**MINE SITE VISIT:  
CYPRUS THOMPSON CREEK**

June 1992

This section of the Technical Resource Document consists of a report on a site visit conducted by EPA to Cyprus Minerals Corporation's Thompson Creek Molybdenum Mine near Challis, Idaho during 1991. A draft of this report was provided to representatives of Cyprus Minerals Corporation, the U.S. Forest Service, and the U.S. Bureau of Land Management. Cyprus Minerals Corporation provided comments, which are presented in Appendix B. The Forest Service and the Bureau of Land Management did not provide comments. EPA's responses to Cyprus' comments are summarized in Appendix C.

Figure 2: Cyprus Thompson Creek Site Map  
(Source: Cyprus, provided at Site Visit)

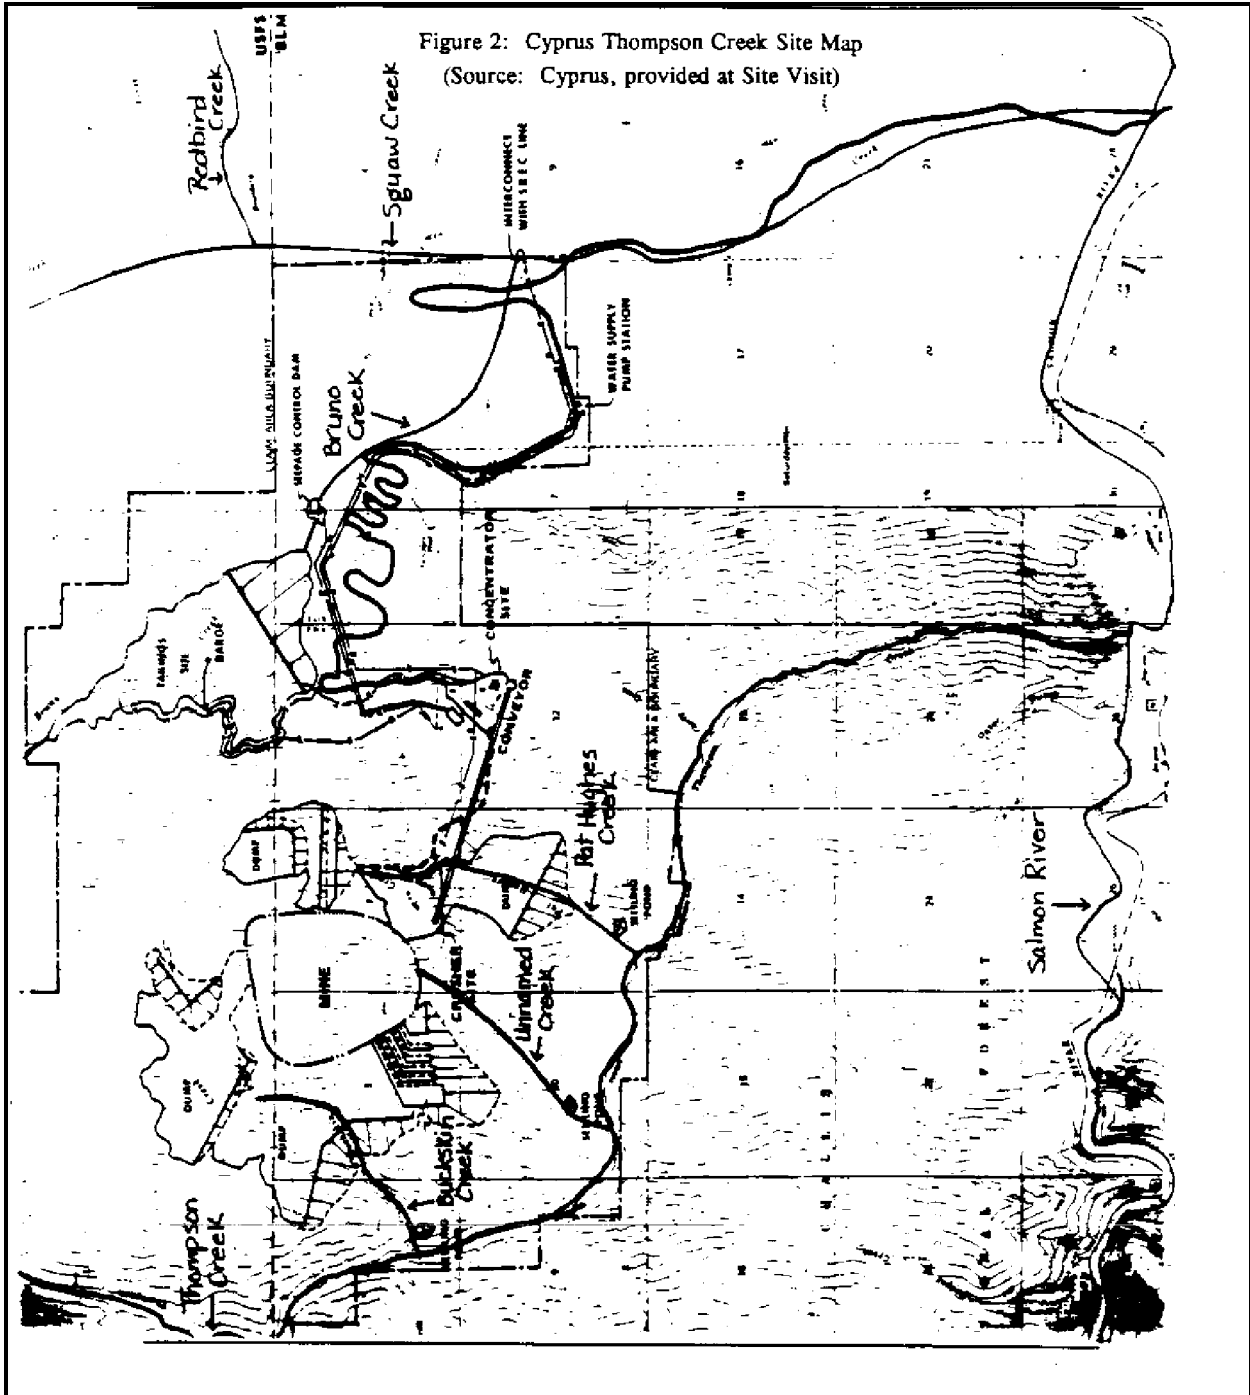
Page 5, Figure 2.: The figure shows a non-existing "unnamed creek" flowing from the pit to the Salmon River between Pat Hughes Creek and Buckskin Creek. It also shows a settling pond on this unnamed and non-existing drainage. This Figure should be corrected.

Comment 4: Cyprus indicated that the draft report described a surface water body, Unnamed Creek, that is not found at the site.

Response: References to Unnamed Creek have been deleted from the text and figures.
